## 2010 Annual Revision Cycle

# National Electrical Code® Committee Report on Comments

A compilation of the documented action on  
comments received by the code-making  
panels for the 2010 Annual Revision Cycle

ILLUSTRATION  
UTILITY ELECTRIC SUPPLY AND  
PREMISES WIRING

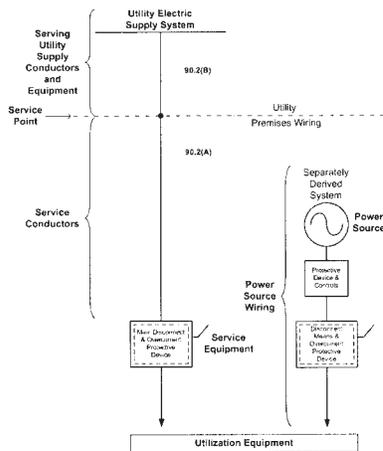
**Comment on Proposal No:** 1-12

**Recommendation:** Add the Informational Annex proposed text:

**Substantiation:** Edison Electric Institute recommends Proposal 1-12 be accepted-in-principle and supports the proposed text in Mr. LaBrake’s negative ballot statement for the change to include it as a new Informational Annex to describe general information regarding utility electric supply to premises wiring. In recognition of Mr. McCarver’s affirmative ballot statement on this proposal, the recommended Annex covers only the electrical service point as discussed in 90.2(B)(5) rather than including communications systems discussed in 90.2(B)(4) since these systems differ from each other and have differing terminology. Refer to the attached Informational Annex that would contain this proposal’s recommendation along with companion comments on Proposals 1-16, 1-53, 1-79, 1-101, 1-104, and 1-106.

The proposed Figure is too general for practical application to all installations.

LABRAKE, JR., N.: This diagram and the associated definitions are proposed for an Annex where they would not be considered mandatory but could provide valuable information concerning the application of the NEC.

I disagree with the Panel statement that the diagram is “too general” for application in the NEC. Similar “general” diagrams exist in Section 210.52(C)(1), 410.2, and 514.3. This diagram (and the others) provides valuable guidance for the application of the NEC. Similarly, I disagree that the diagram does not provide additional clarity and usability to the NEC.

**Comment on Proposal No:** 1-12

**Recommendation:** The panel action should have been to Accept In Principle, with the principle being to show the proposed figure as a FPN to 90.2(B)(5) so that it is not considered mandatory text.

**Substantiation:** The drawing is a good representation of the Service Point definition and shows that this point is not defined by a specific piece of equipment like a disconnecting means, but will change depending on the utility/custom arrangements. The coverage of the Code and where it applies versus the NESC is a complex one. Even though this figure may not perfectly apply to all examples, it is better than what we have available today.

**Informational Note Figure 694.1(A) Identification of Small Wind Electric System Components – Interactive System.**

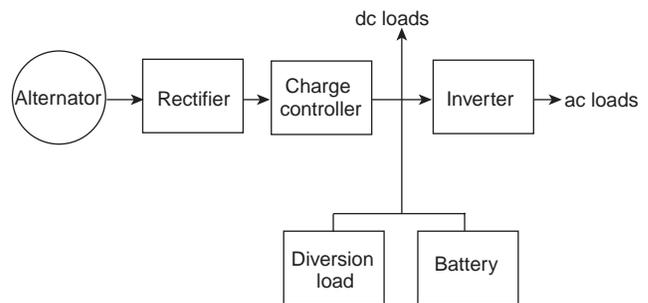
Informational Note: These Systems Small wind electric systems can be interactive with other electrical power production sources or might be stand-alone systems. These systems can have ac or dc output, with or without electrical energy storage, such as batteries. See Informational Note Figures 694.1 and 694.2.
